we
PROCEDURE REVISION REQUEST

PROCEDURE NO. HNP- HNP-8029

Revision No. 1

PLANT SITE SURVEYA. PURPOSE

FIGURE 1
PLANT SITE MAP

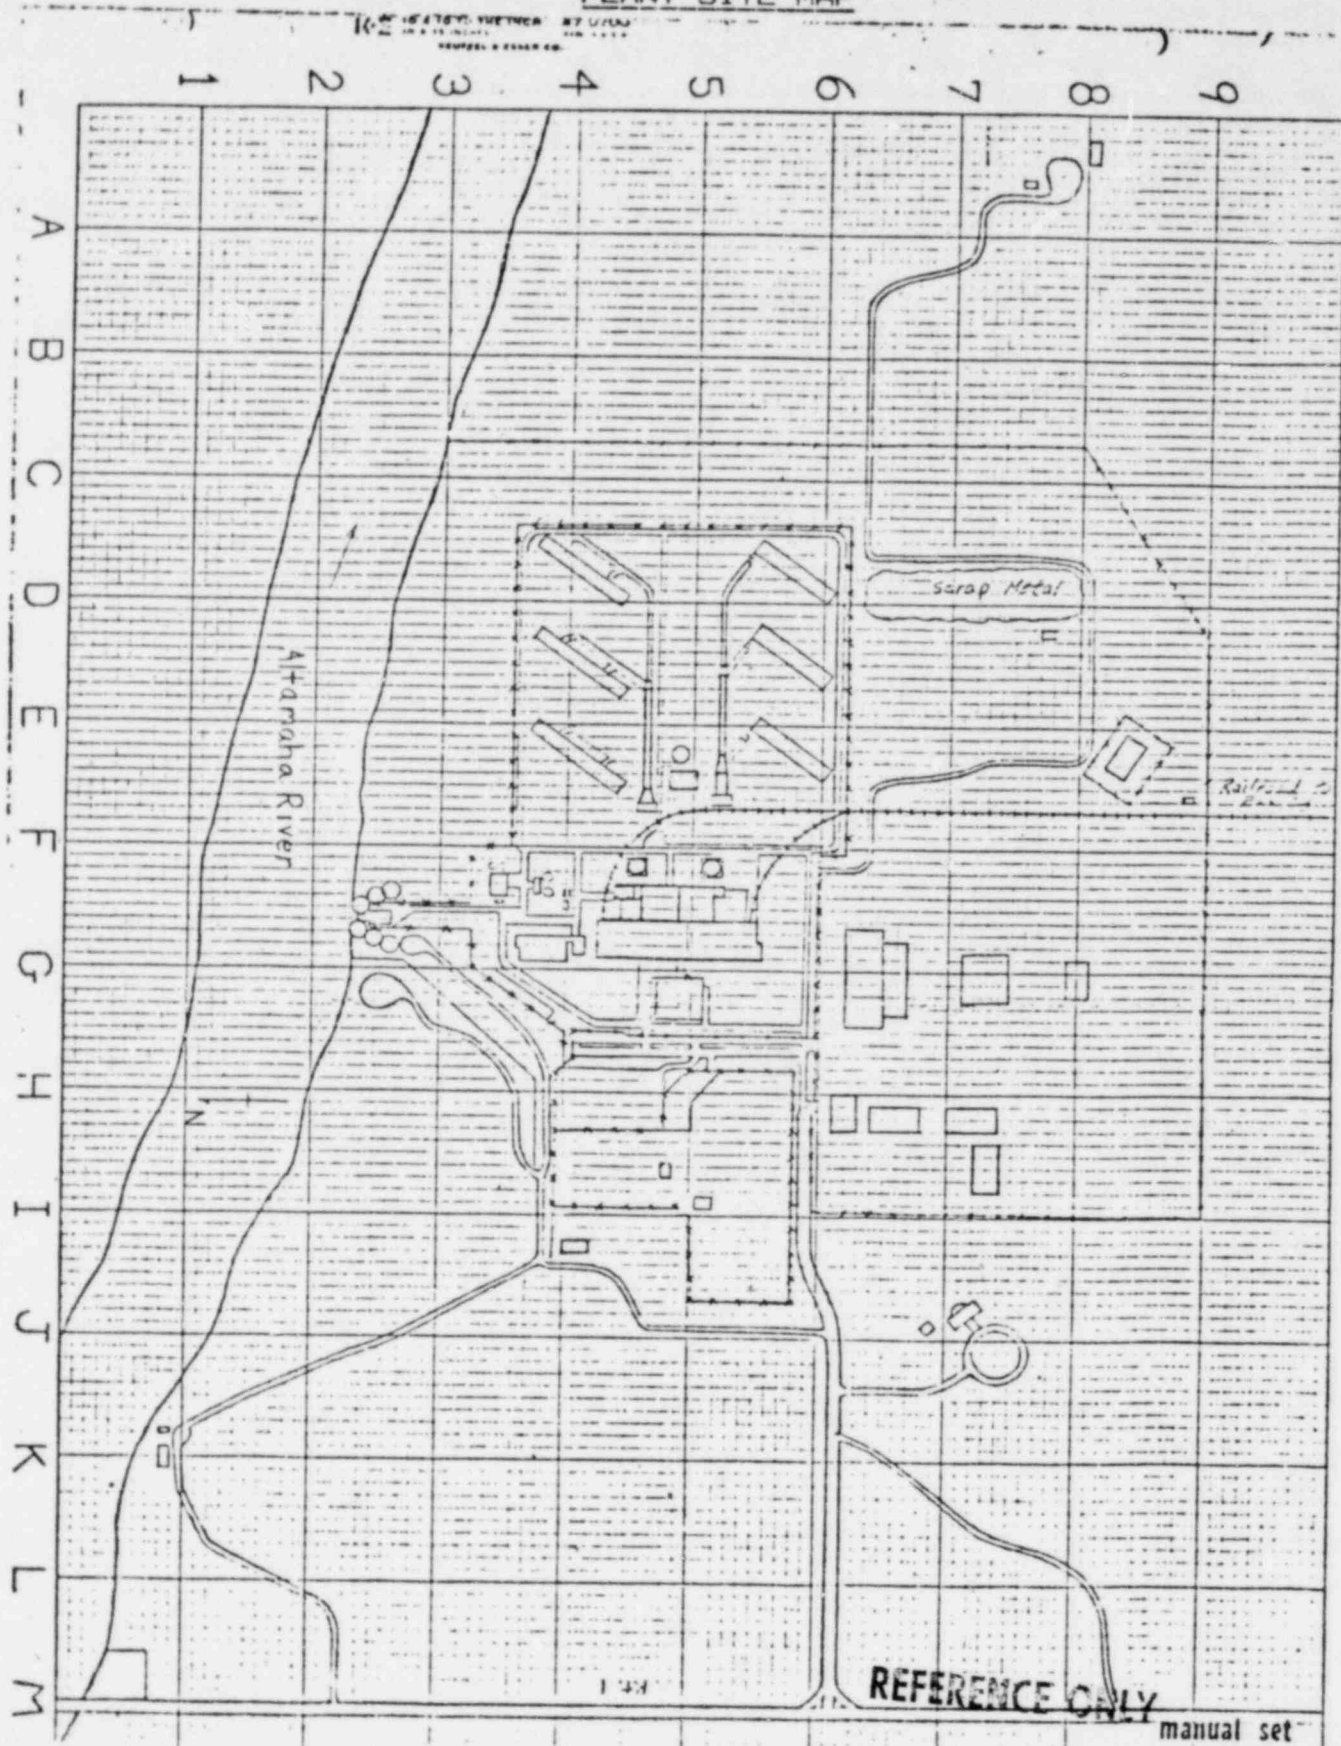
REASON FOR REQUEST TO PROVIDE A MAP THAT INDICATES

THE APPROXIMATE SURVEY AREAS. ALSO, TO INCLUDE THE
MICRO-METER.

Add page 3

Survey all grid areas marked on the plant site map. See attached map.
